HISTORIC AND DESIGN REVIEW COMMISSION

October 06, 2021

HDRC CASE NO: 2021-380
ADDRESS: 232 LAVACA ST
LEGAL DESCRIPTION: NCB 713 BLK 10 LOT 16 & E 4 FT OF 15
ZONING: RM-4,H
CITY COUNCIL DIST.: 1
DISTRICT: Lavaca Historic District
APPLICANT: Clint Belew/BelewHouse LLC
OWNER: BelewHouse LLC
TYPE OF WORK: Removal of existing additions, construction of a new addition, exterior modifications, site modifications
APPLICATION RECEIVED: August 27, 2021
60-DAY REVIEW: Not applicable due to City Council Emergency Orders Stephanie Phillips
CASE MANAGER:

PROPOSED 4'-0" FENCE EXAMPLE

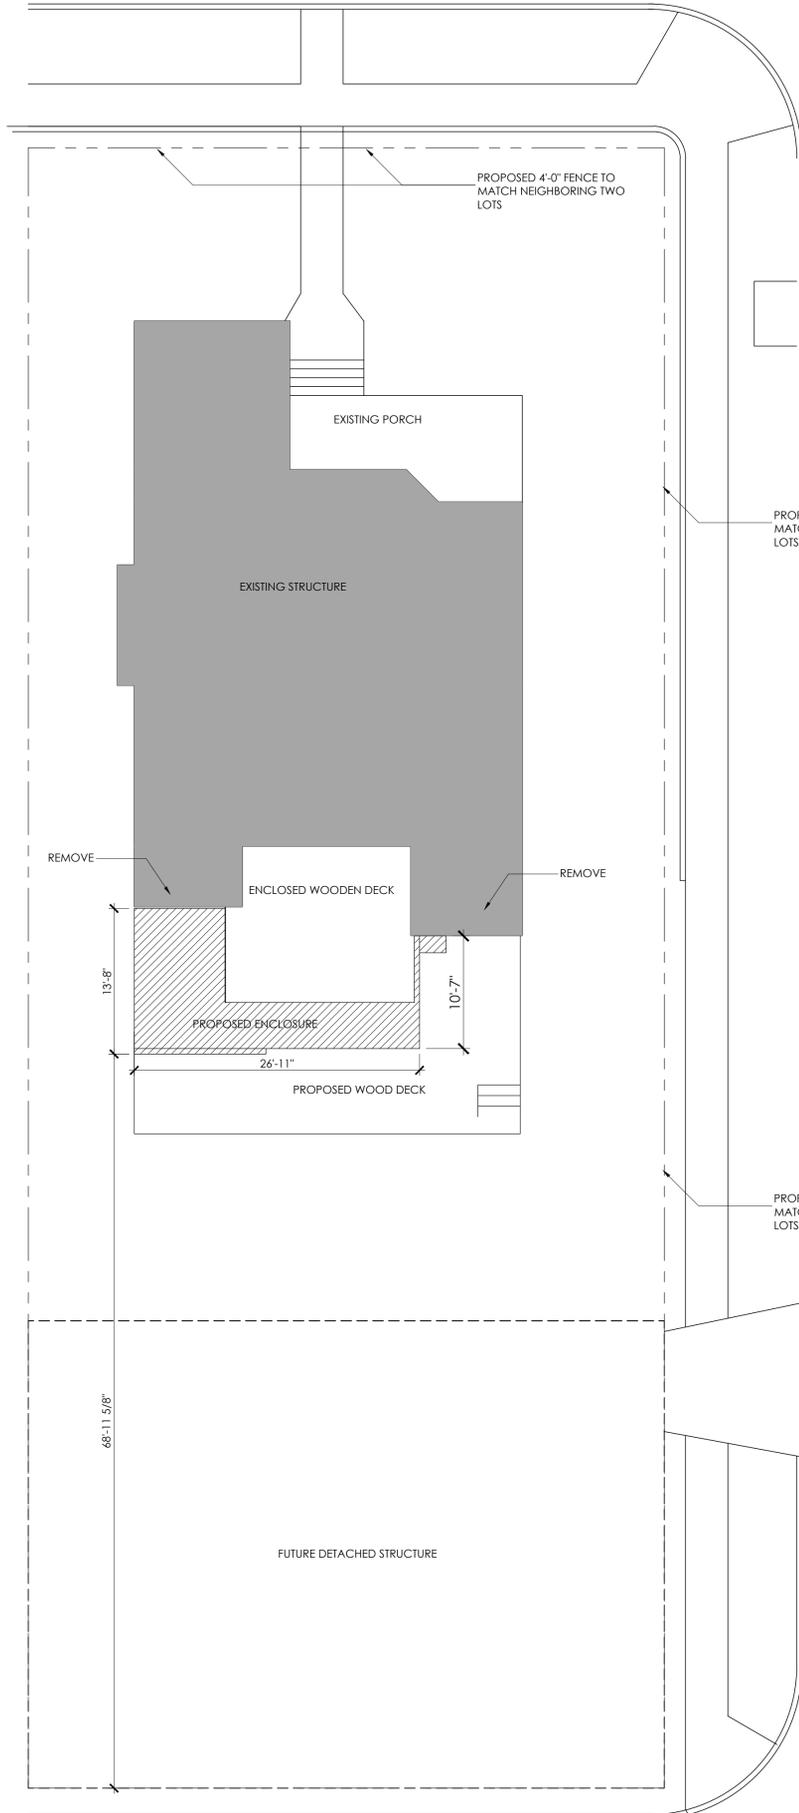
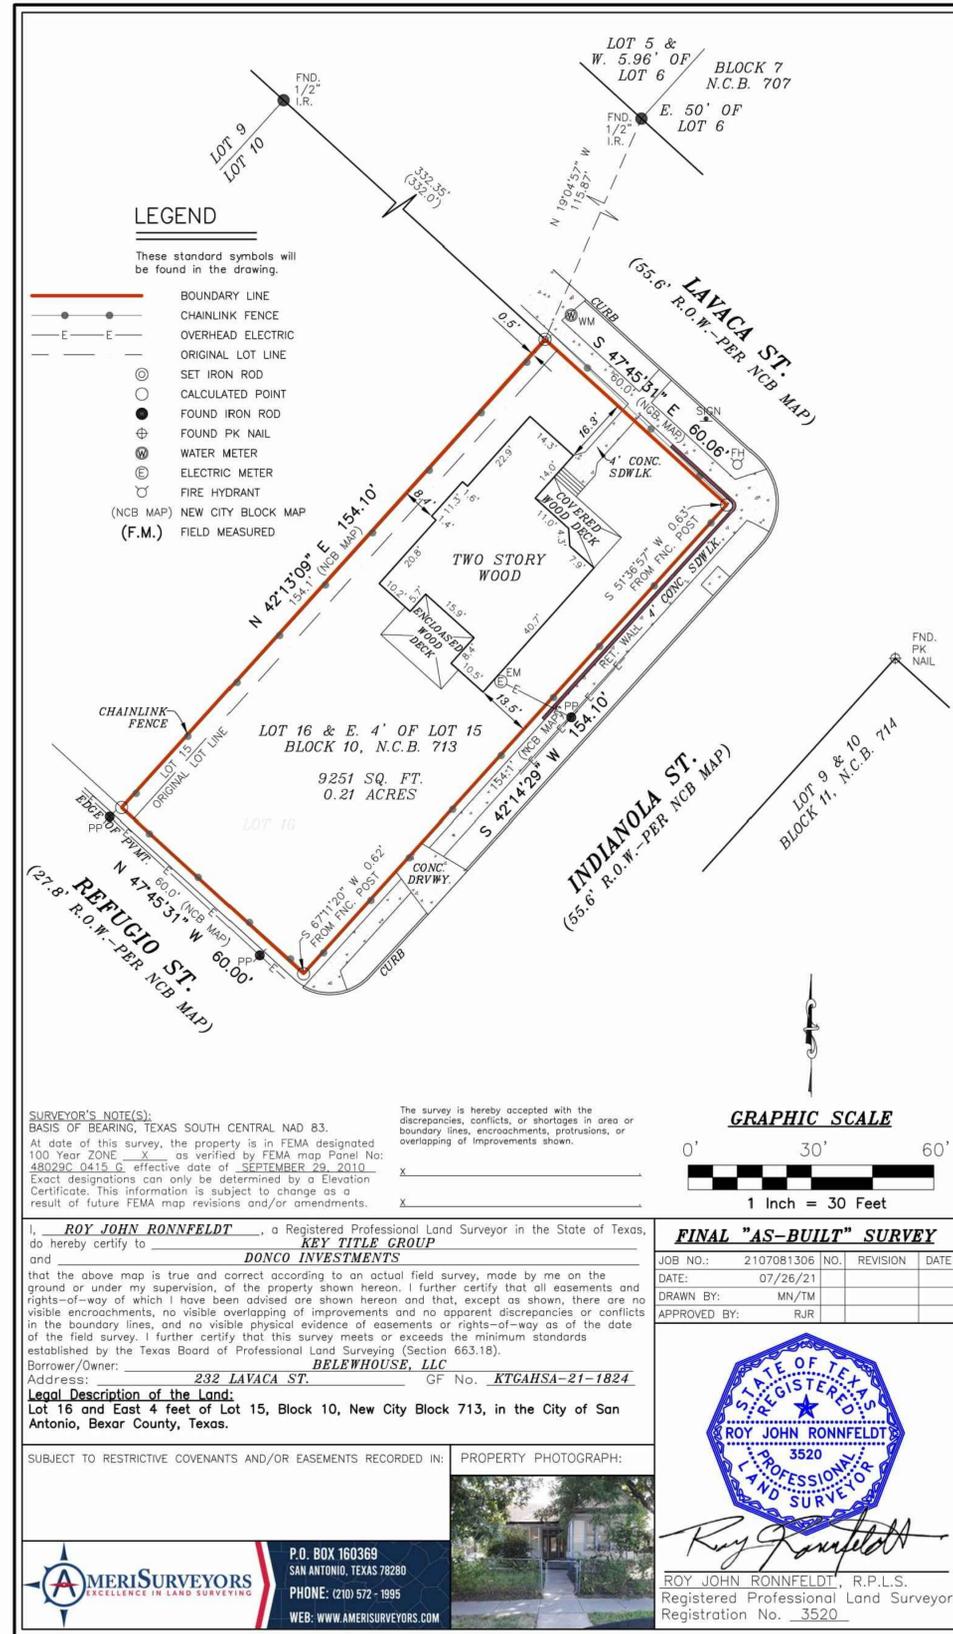
- p. **FENCING** – The submitted renderings include new cattle panel style fencing. The applicant is required to submit a fencing site plan and detailed material specifications and/or drawings that indicated the proposed height as part of an application for review and approval.

- v. That the applicant installs a standing seam metal roof featuring panels that are 18 to 21 inches wide, seams that are 1 to 2 inches high, a crimped ridge seam, and a standard galvalume finish. Panels should be smooth without striation or corrugation. Ridges are to feature a double-munch or crimped ridge configuration; no vented ridge caps or end caps are allowed. An on-site inspection must be scheduled with OHP staff prior to the start of work to verify that the roofing material matches the approved specifications. All chimney, flue, and related existing roof details must be preserved.
- vi. That the applicant retain all existing chimneys, dormer vents, dormer shingles, and other significant architectural details.
- vii. That the applicant submits drawings and material specifications for any proposed front yard fencing for final approval.

SHEET TITLE
Exterior Elevations

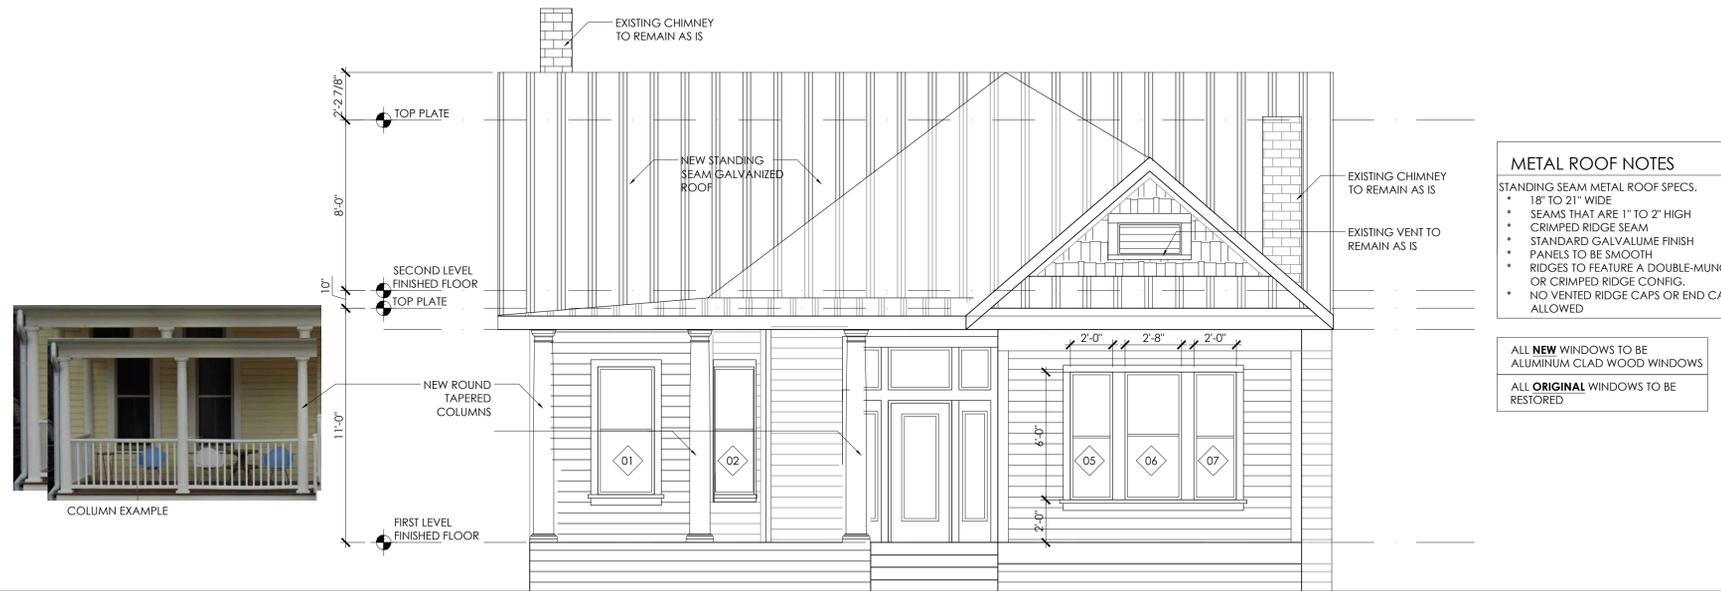
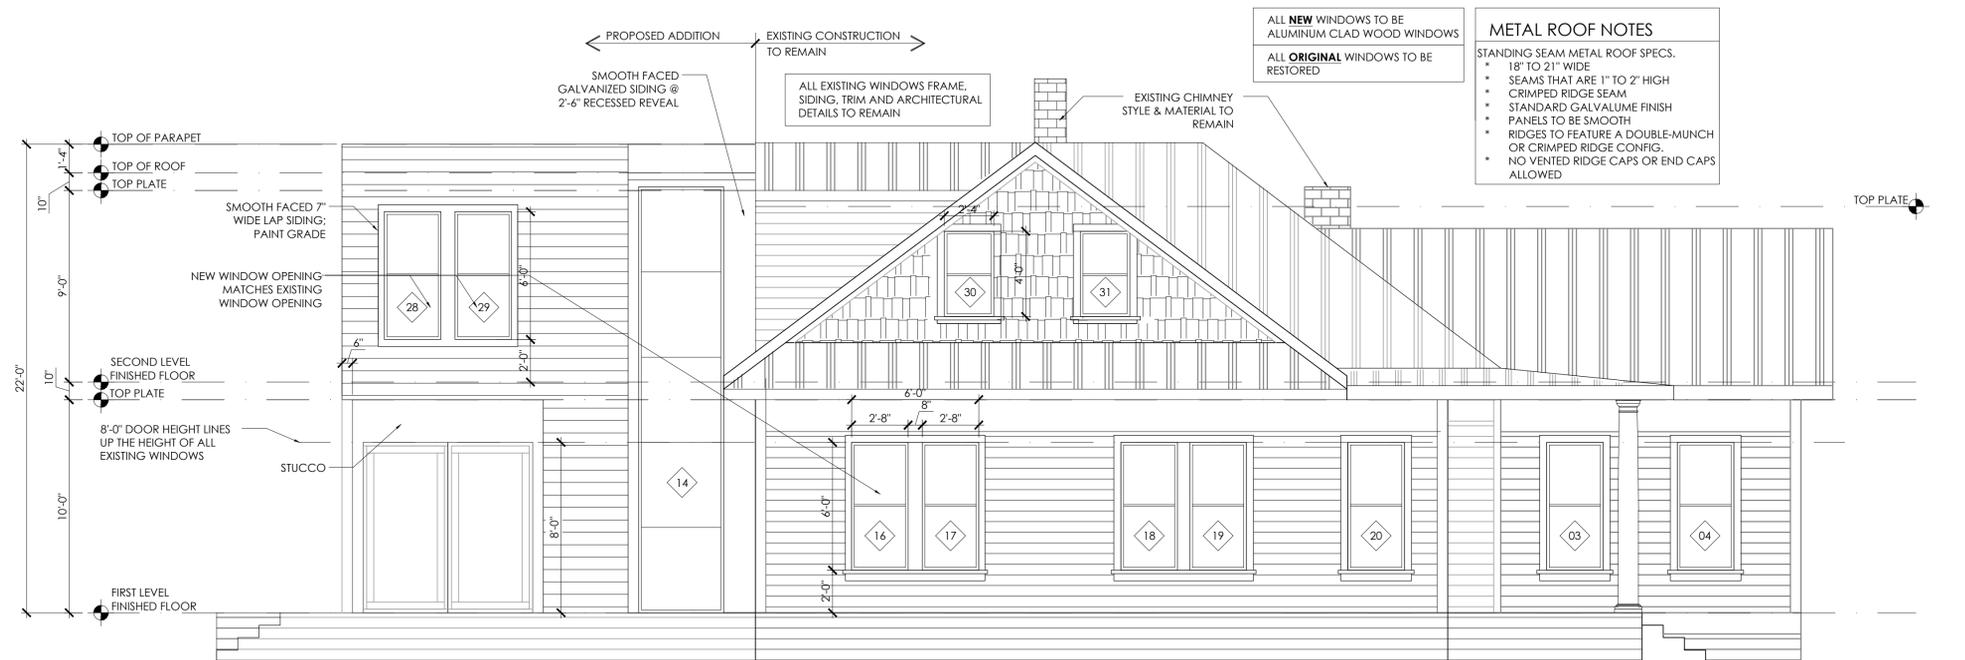
- h. **FENESTRATION** – According to the Historic Design Guidelines, openings in new construction should use traditional dimensions and profiles found on the primary structure or within the historic district. Based on the submitted elevations, the applicant is requesting window sizes and proportions that are a modern interpretation of those found on the primary structure that also incorporate traditional ganged trim conditions, recess, inset, and configurations. Staff finds the proposed fenestration appropriate with the stipulations listed in the recommendation.

- i. **MATERIALITY** – The applicant has proposed to use composite lap siding, metal and/or hardi panel siding, and a standing seam metal roof. The window and door materials are not indicated. Staff finds that the material palette should respond to the design modifications outlined in staff’s findings and should minimize the visual weight of the proposed addition. The Guidelines encourage a material palette that responds to the existing historic structure and historic structures in the vicinity.

- j. **ROOF FORM** – The proposed 2-story rear addition will utilize a flat roof form. According to the Guidelines, roof forms on additions should respond to the roof form of the primary structure and predominant roof forms used historically in the district. Staff finds that the applicant should modify the roof form to feature a gable, hip, or another form that is more consistent with the primary structure and roof forms found historically. Staff encourages the applicant to incorporate a similar roof form as the existing addition, which nests within the existing primary structure’s roofline and is complementary while clearly reading as a new addition.

- k. **ARCHITECTURAL DETAILS** - According to the Guidelines for Additions, new additions should feature architectural details that are in keeping with the architectural style of the original structure. Details should be simple in design and compliment the character of the original structure. Architectural details that are more ornate or elaborate than those found on the original structure should not be used to avoid drawing undue attention to the addition. While staff finds that the modern interpretations of the specific details, forms, and design elements found on the primary structure may be appropriate, staff does not find the addition consistent at this time due to the flat roof form and material palette.

- i. That the applicant modify the proposed roof form to be more consistent with the existing roof forms on the lot and the surrounding historic roof forms as noted in finding j. Staff recommends that the applicant incorporate a similar roof form as the existing addition.

- ii. That the applicant explore material palettes that minimize the visual weight of the rear addition as noted in finding i.
- iii. That the applicant retain all existing window locations and restore the original wood windows. The applicant is required to submit a window schedule that illustrates any windows to be replaced on the primary historic structure, if applicable, along with supporting evidence that the window sashes are deteriorated beyond repair. All existing openings must be retained as noted in findings l through o.

- iv. That the applicant submits final window specifications for the addition to staff for review and approval. Windows should be fully wood or aluminum clad wood and feature an inset of two (2) inches within facades and should feature profiles that are found historically within the immediate vicinity. White color is not allowed, and color selection should be presented to staff. Meeting rails must be no taller than 1.25” and stiles no wider than 2.25”. There should be a minimum of two inches in depth between the front face of the window trim and the front face of the top window sash. This must be accomplished by recessing the window sufficiently within
